PCN# : P174A
Issue Date : 22/07/2011

DESIGN/PROCESS CHANGE NOTIFICATION

PACKAGE OUTLINE COMPARISON

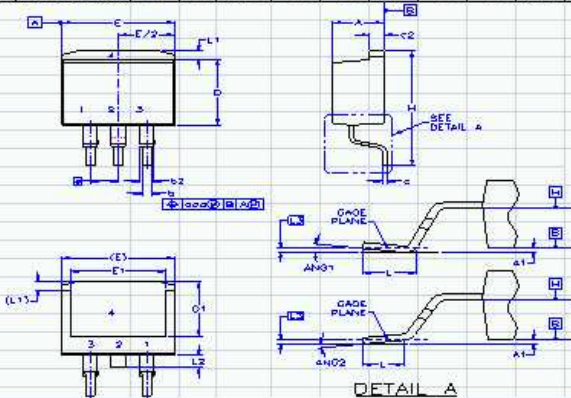
These devices are still within the marketing outline specification and unit marking will just follow current plant code designation which is D for Cebu built and 1 for Suzhou built.
